### ADDENDUM

PROJECT TITLE: PUBLIC SPACE AT MARKET SLIP & HARBOUR PASSAGE EXTENSION	ADD. NO: 1
TENDER NO: 2022-081201T	DATE: June 30th, 2022
PAGE 1 of 2 (Including Confirmation Sheet)

Public Space at Market Slip & Harbour Passage Extension

ADDENI	OUM NO:	<mark>1</mark>
DATE	June 2	27, 2022
PAGE	1	OF 6
CONTRA	ACT NO:	2022-081201T

DATE PRINTED:	DESIGNED BY:			
10.06.2022	DG			
DRAWN BY:	CHECKED BY:			
BC, MB	DG			
CLIENT PROJECT No.:	GG PROJECT NO:			
2022-081201T	2107			
SCALE:	DATE:			
	10.06.2022			
SHEET NUMBER				
LS1.1

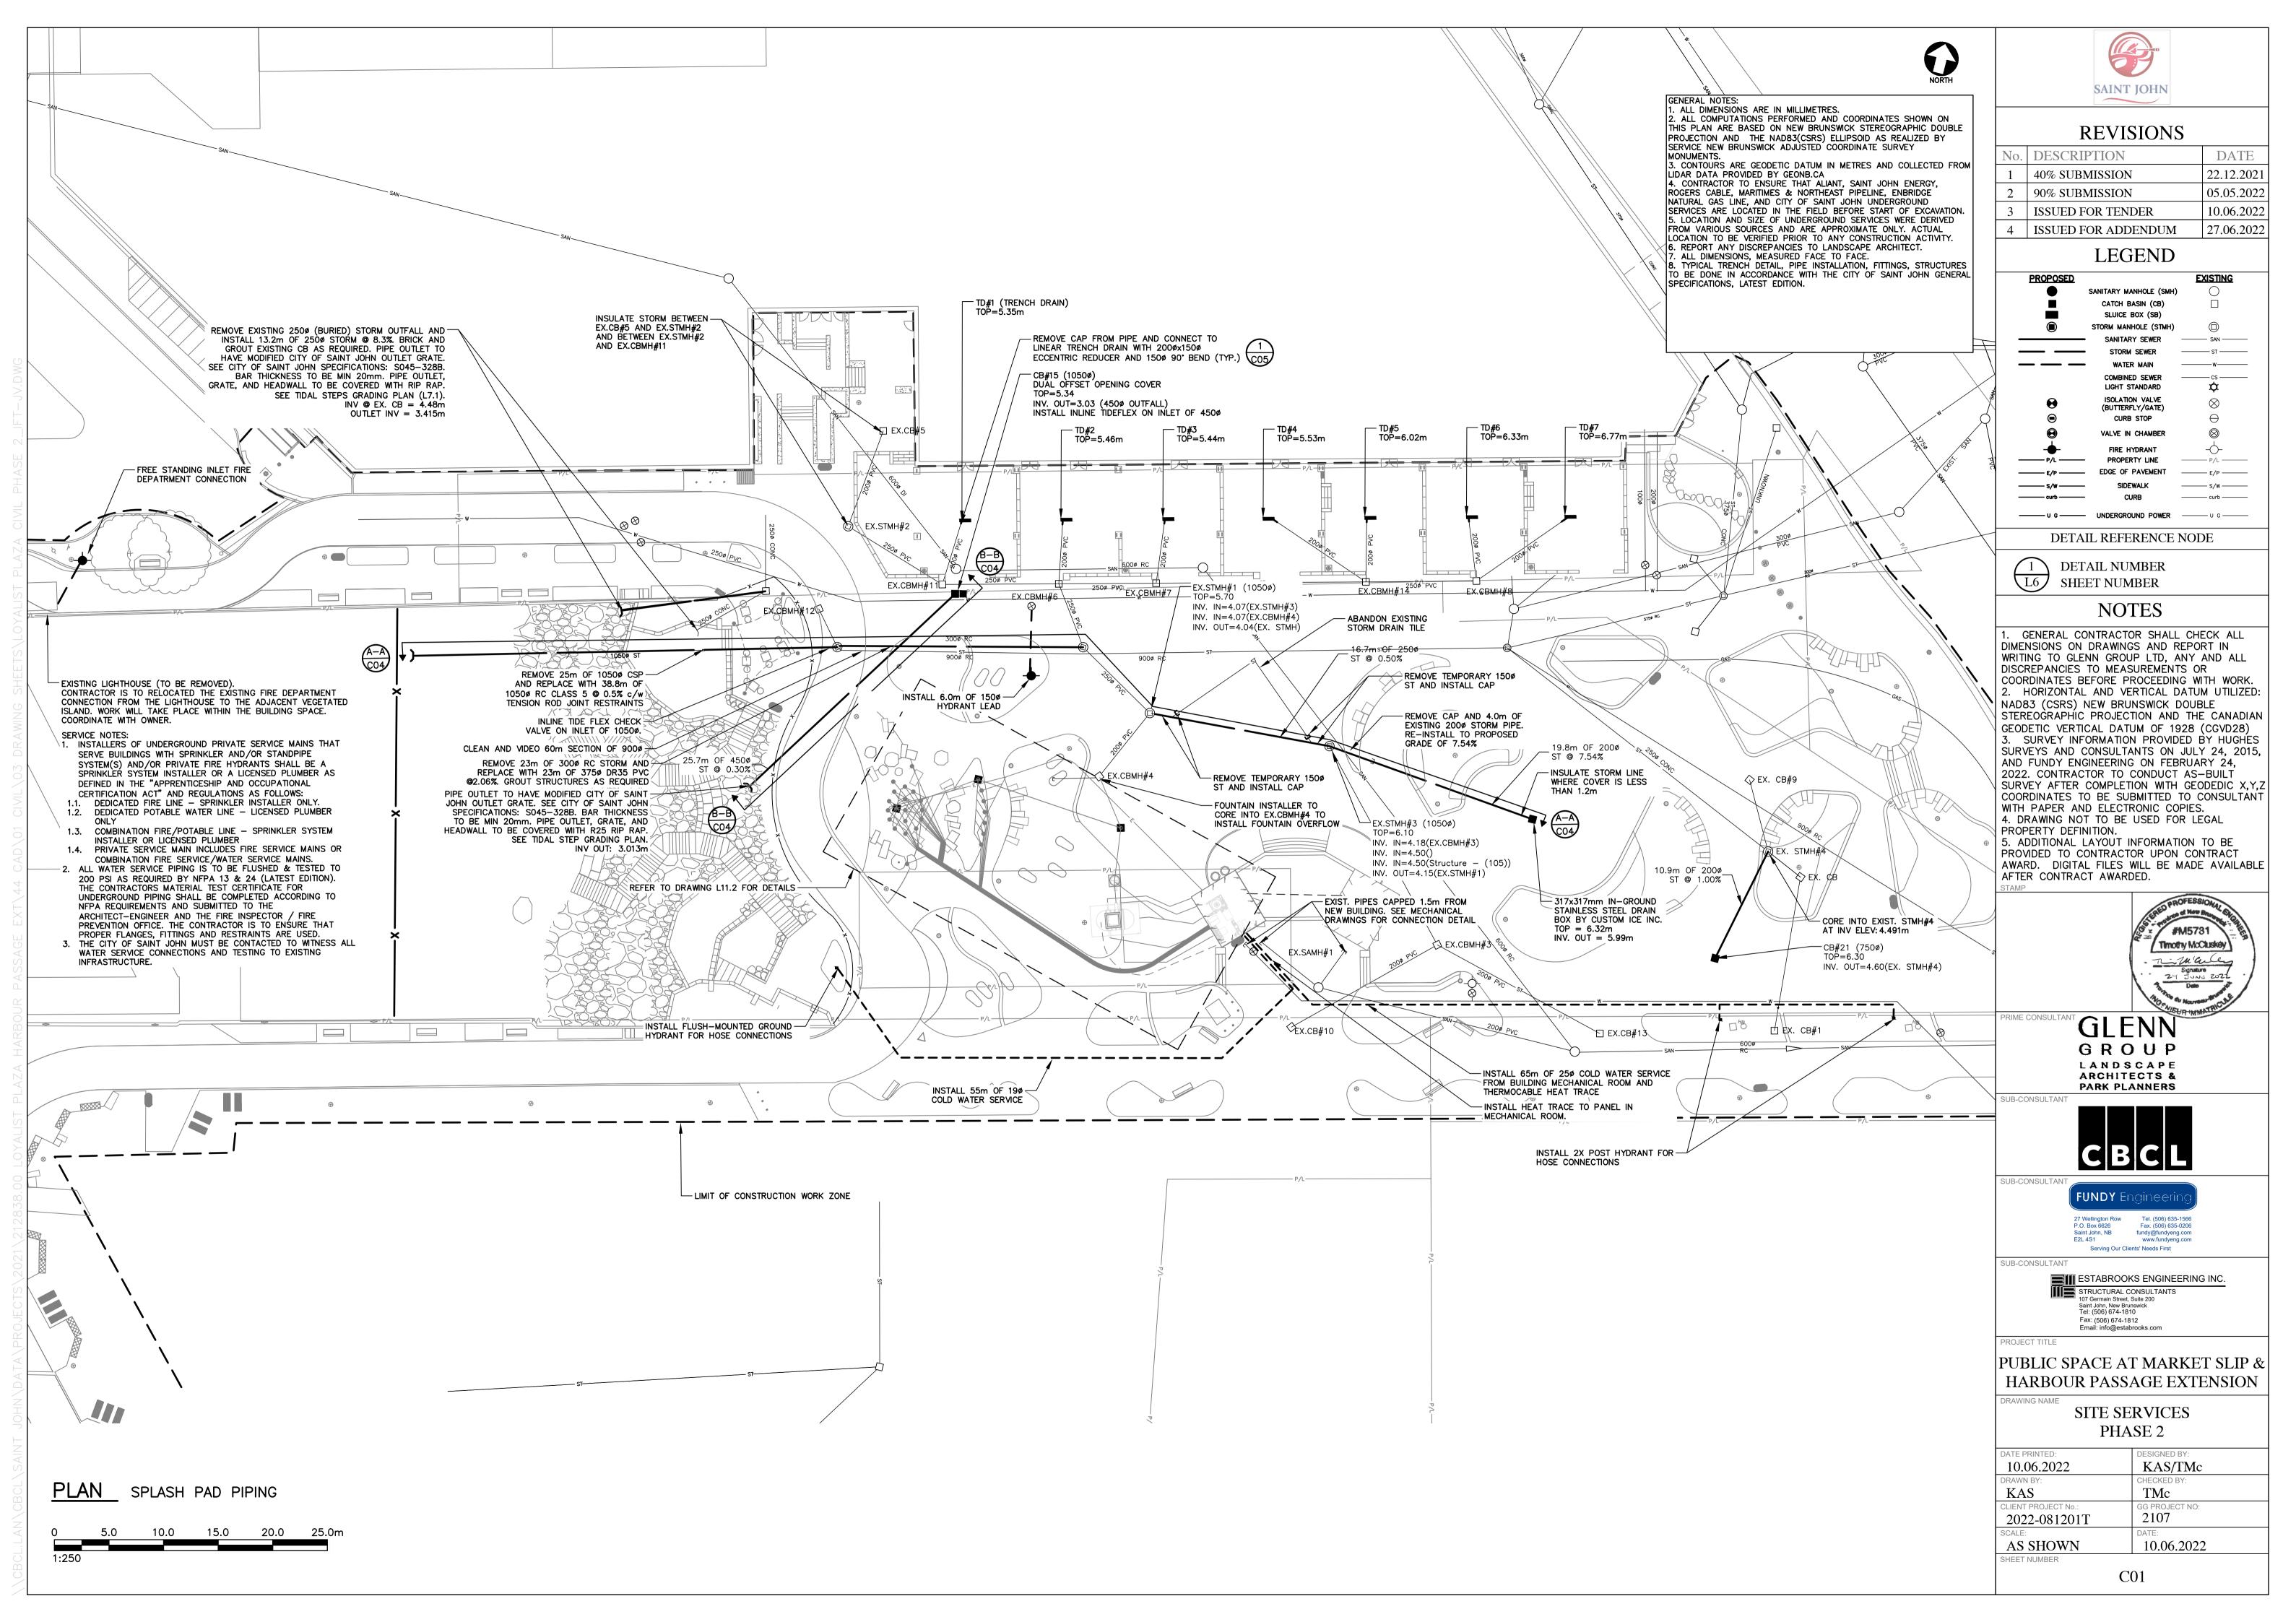
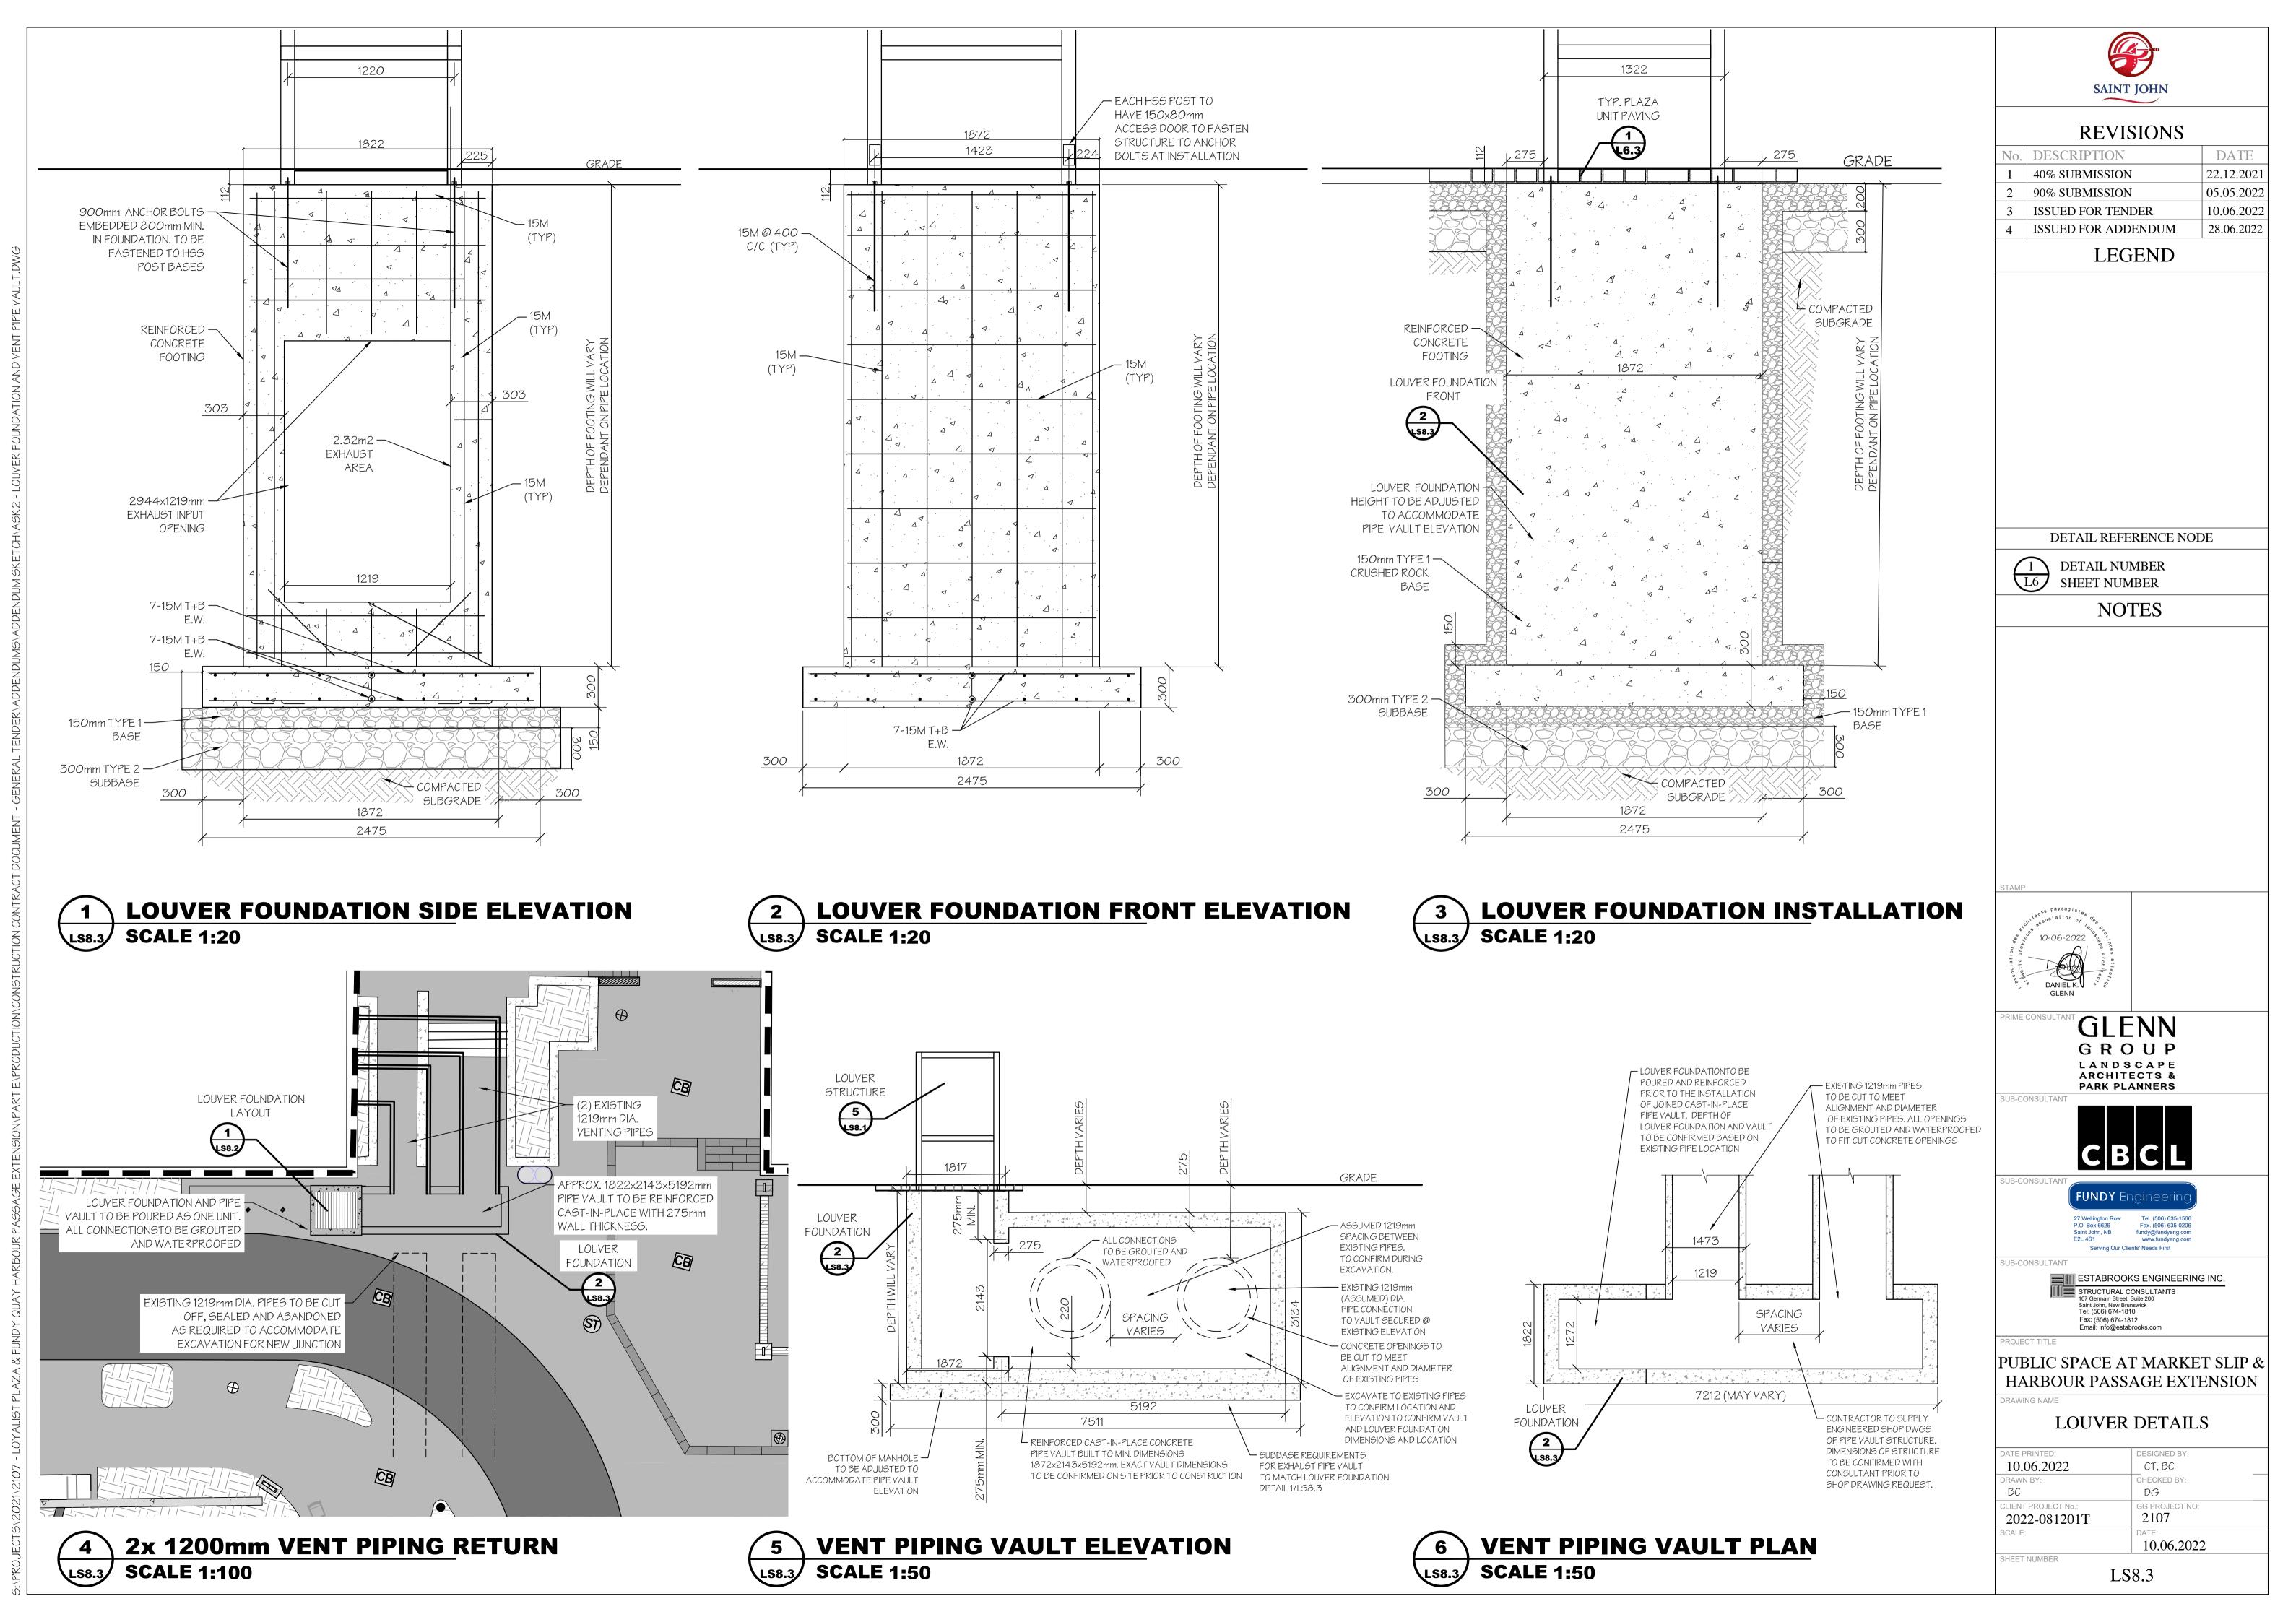
On sheet LS1.1 replace the foundation with the provided foundation rebar design as shown on 1 - LS1.1 and 4 - LS1.1 as indicated on drawing LS1.1 Issued for Addendum Revision 4.

LS10.3

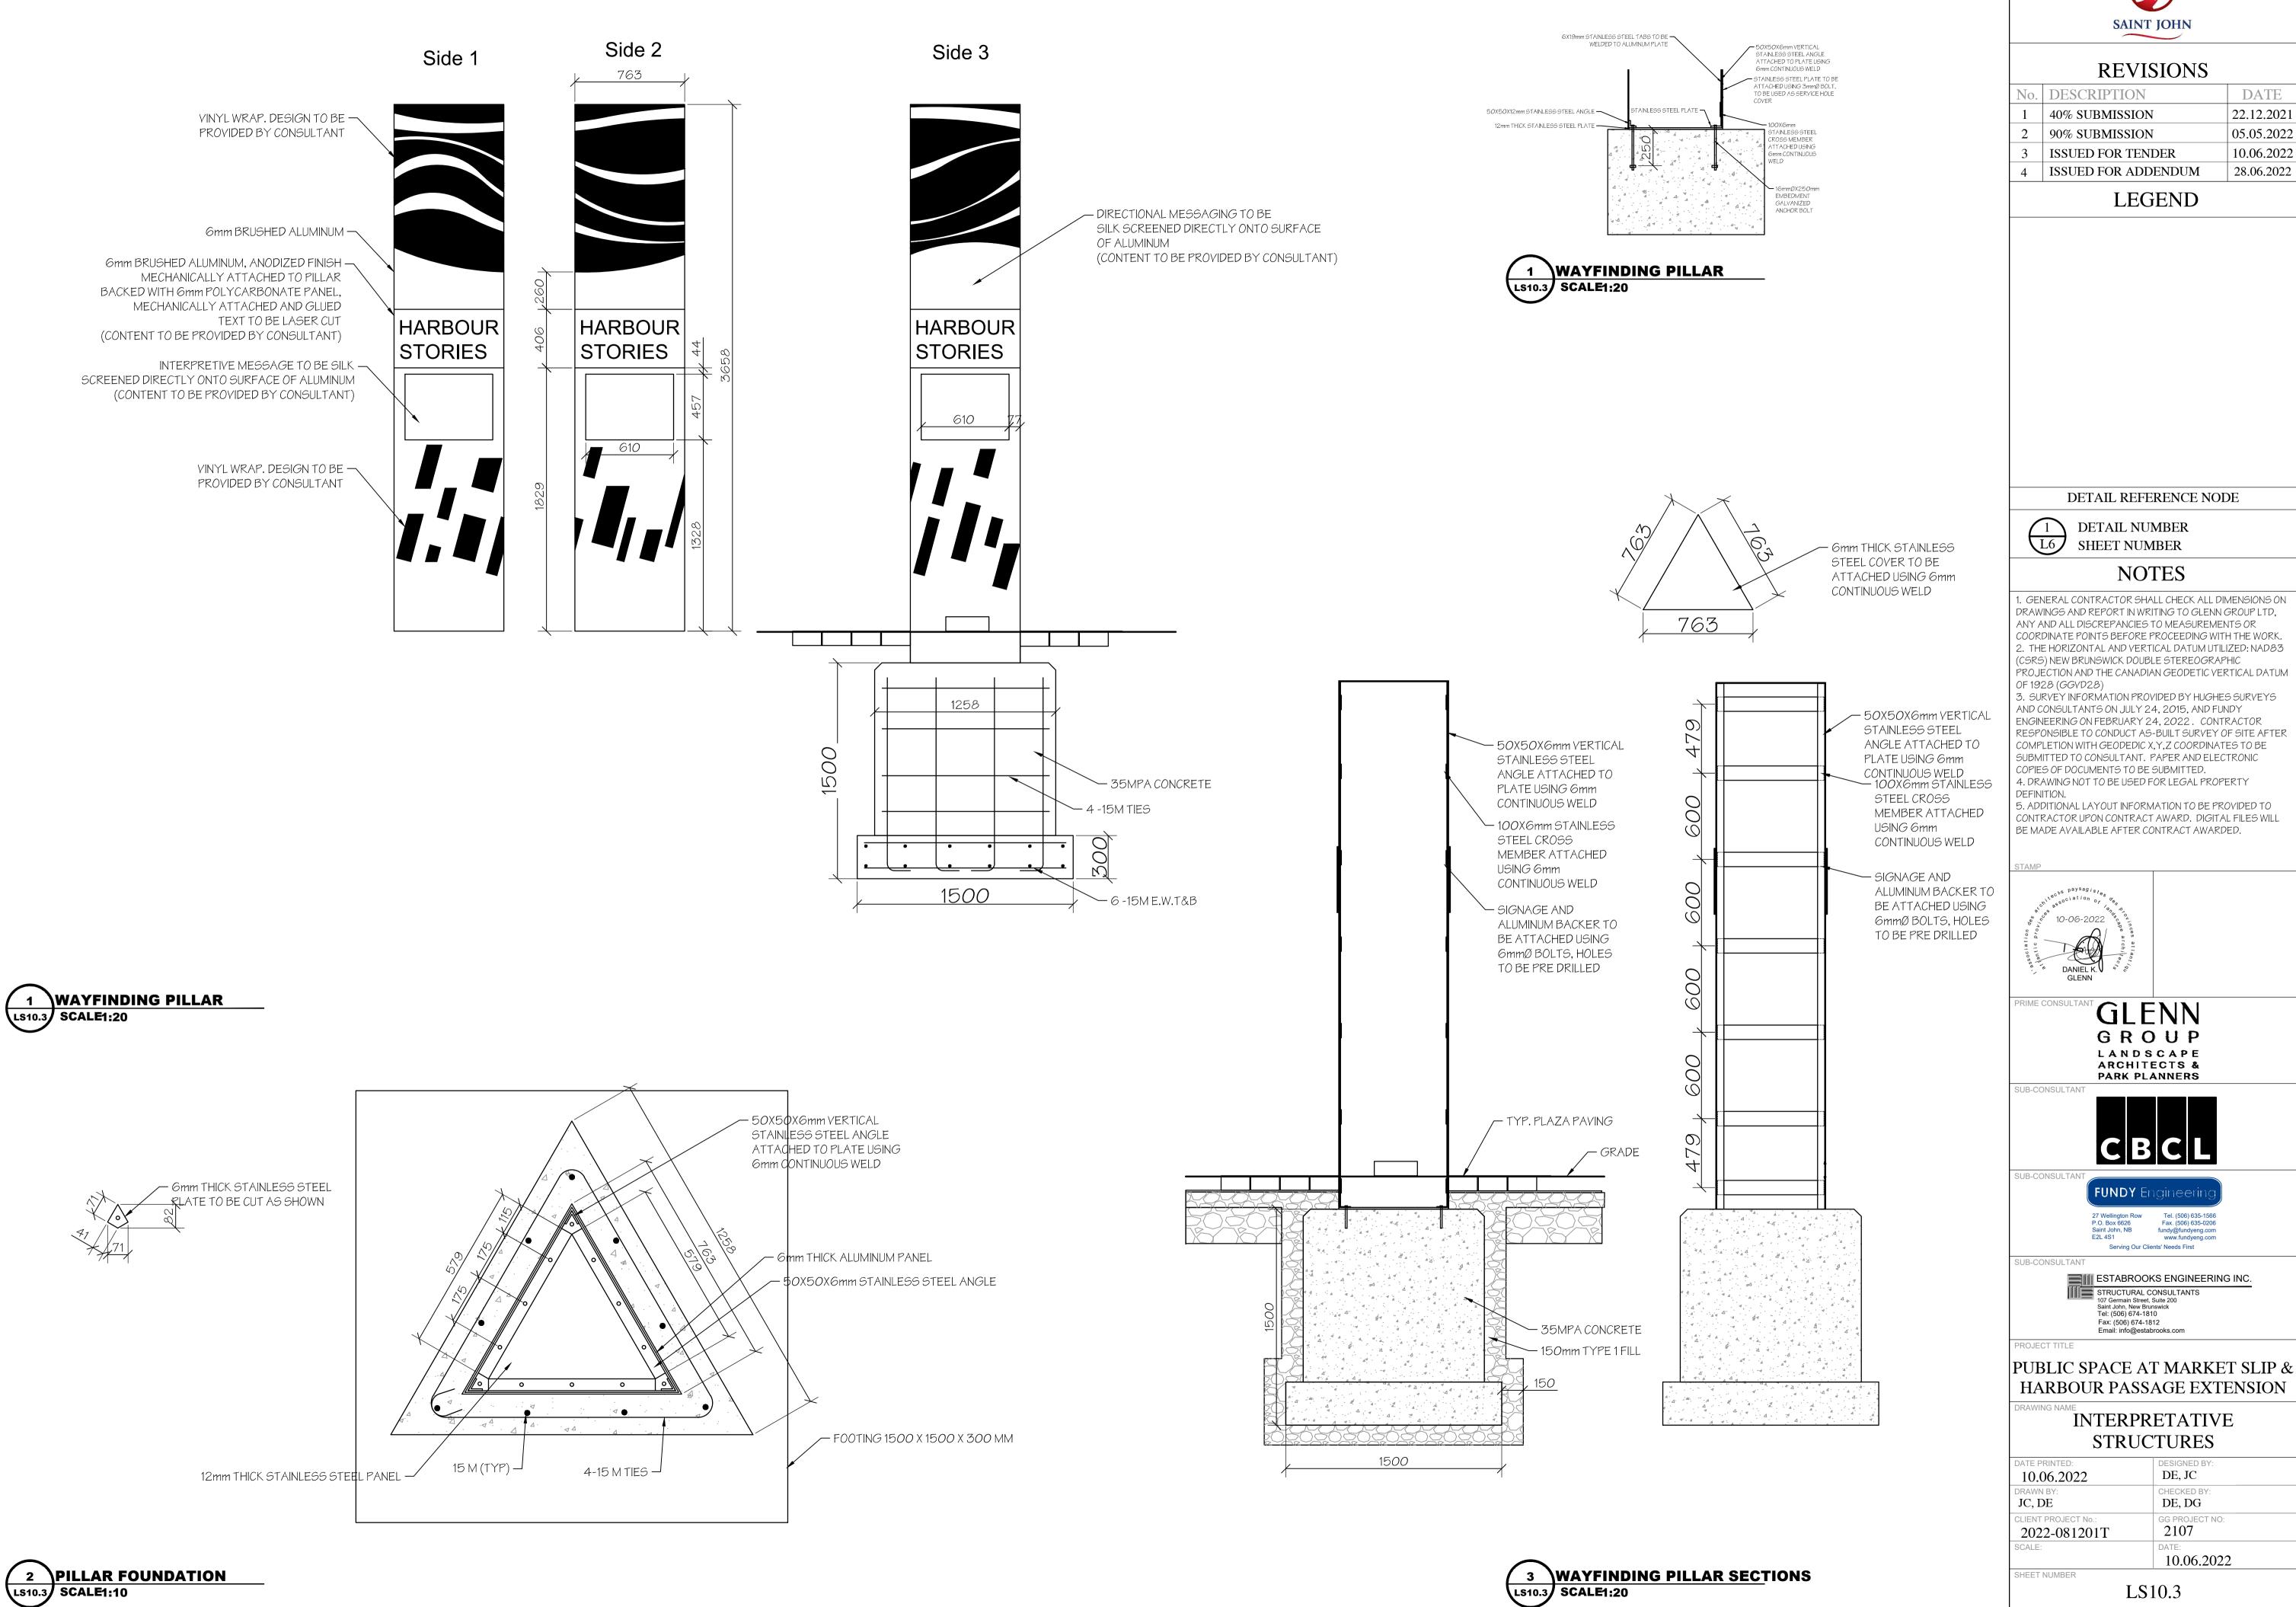
On sheet LS10.3 replace the foundation with the provided foundation rebar design as shown on all detail as indicated on LS10.3 Issued for Addendum Revision 4.
